**Project No. 35077**

**Amendment No. 1**

**Generation Interconnection Agreement**

**FIRST AMENDMENT TO THE  
ERCOT STANDARD GENERATION INTERCONNECTION AGREEMENT**

### One Line Diagram – TSP Interconnection Facilities, Generation Interconnection Facilities and the Plant

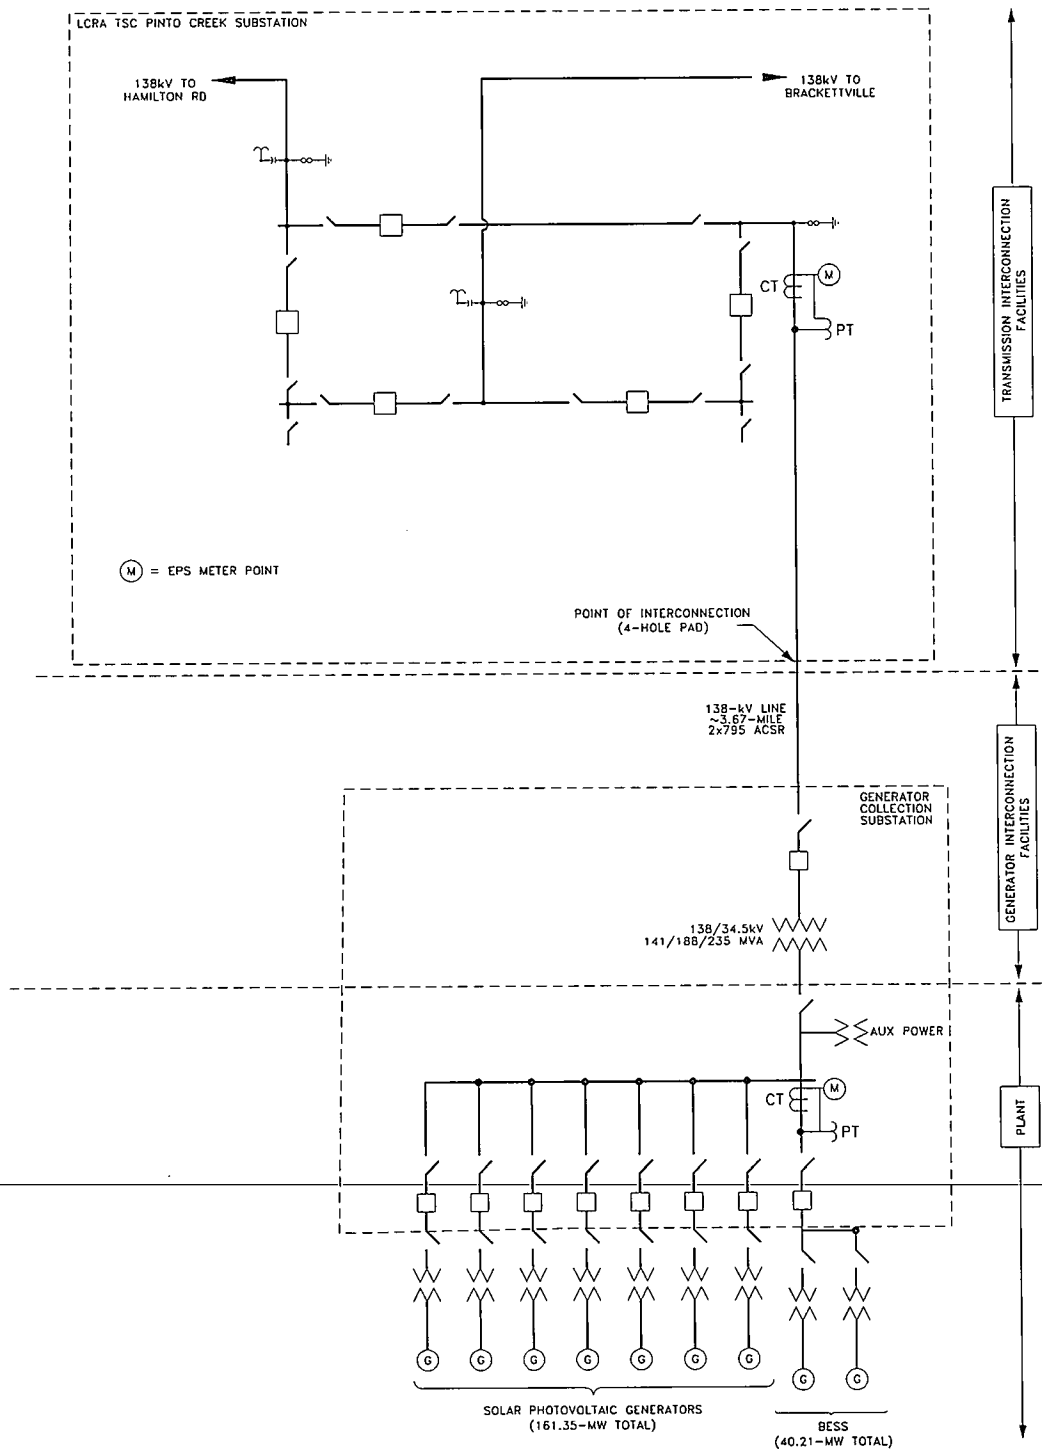
**WHEREAS**, the Generator notified TSP of a change in the design of the Plant as contemplated in the Agreement which will require TSP to install additional facilities to meter the Generator’s Wholesale Storage Load;

1. Exhibits “B”, “C”, “C2”, and “E” are deleted in their entirety and the Exhibits “B”, “C”, “C2”, and “E” attached to this Amendment are hereby added to the Agreement in lieu thereof.
2. This Amendment will become effective upon execution by both Parties.

- B. Generator acknowledges that the Plant will engage in wholesale energy storage in accordance with the PUCT Rules and ERCOT Requirements for a Wholesale Storage Load (“WSL”). As such, TSP will install and own additional primary and backup EPS meters for the WSL in order to separately meter the WSL from any auxiliary or non-WSL energy and power that the Plant and GIF may consume from the 138-kV ERCOT Transmission Grid through the Point of Interconnection. The TSP’s WSL EPS metering will be located in a suitable space allocated by Generator in the control building of the Generator’s 138-kV interconnection substation. The Generator shall install, for TSP’s use, adequately rated instrument transformers to accurately meter

the WSL. Generator shall, no fewer than one hundred twenty (120) days prior to the In-Service Date, provide, for TSP's review and approval, the necessary equipment specifications, factory test reports, vendor cut-sheets and any other engineering drawings for the aforementioned 34.5-kV instrument transformers to be installed by Generator and used by TSP to meter the WSL. The Generator shall provide the cable and suitable conduit paths between the Generator's 34.5-kV WSL instrument transformers and the Generator's control building for TSP's use in metering the WSL. TSP will terminate control cable to the WSL EPS meters.

- E. Three (3) 34.5-kV metering current transformers and three (3) 34.5-kV metering accuracy voltage transformers for TSP's use in metering the WSL;
  - F. Suitable conduit paths from the Generator's control building to the Generator owned 34.5-kV metering current transformers associated with the WSL and 34.5-kV metering accuracy voltage transformers with review and acceptance of design by TSP;

- (c) Three (3) 138-kV extended range metering CT's; and
  - (d) Three (3) 138-kV metering class voltage transformers.
9. WSL EPS Metering Facilities located at the Generator's interconnection substation which will include the following:

- (a) One (1) WSL EPS metering panel; and
  - (b) Two (2) WSL EPS meters (one primary meter and one backup meter).
10. Telecommunication Facilities: Generator shall, in accordance with ERCOT Requirements and Good Utility Practice, provide communications facilities that are, or may in the future be, necessary for effective interconnected operation of the Plant and GIF with the transmission system. The Generator shall own, and be responsible for installation, operation, and maintenance of fiber optic communication facilities between the Generator's transmission voltage substation and the POI Structure at the Point of Interconnection. Generator will complete its OPGW termination and dress out in a manner acceptable to TSP inside the TSP provided fiber splice boxes on the POI Structure. TSP will provide the splicing of fibers within the splice boxes at the Point of Interconnection. The Generator shall provide the dedicated channels or fiber pairs for necessary items including Generator's 138-kV radial circuit protective relaying, TSP's WSL EPS metering, and Remedial Action Scheme communications. Generator shall provide any necessary fiber optic jumpers from Generator's fiber patch panel(s) to the TSP's WSL EPS meters. TSP will provide fiber transceivers at the WSL EPS metering and terminate the fiber. Voice communications provided by the Generator shall at a minimum include one POTS (plain old telephone service) or equivalent voice circuit in the Generator's substation control buildings.
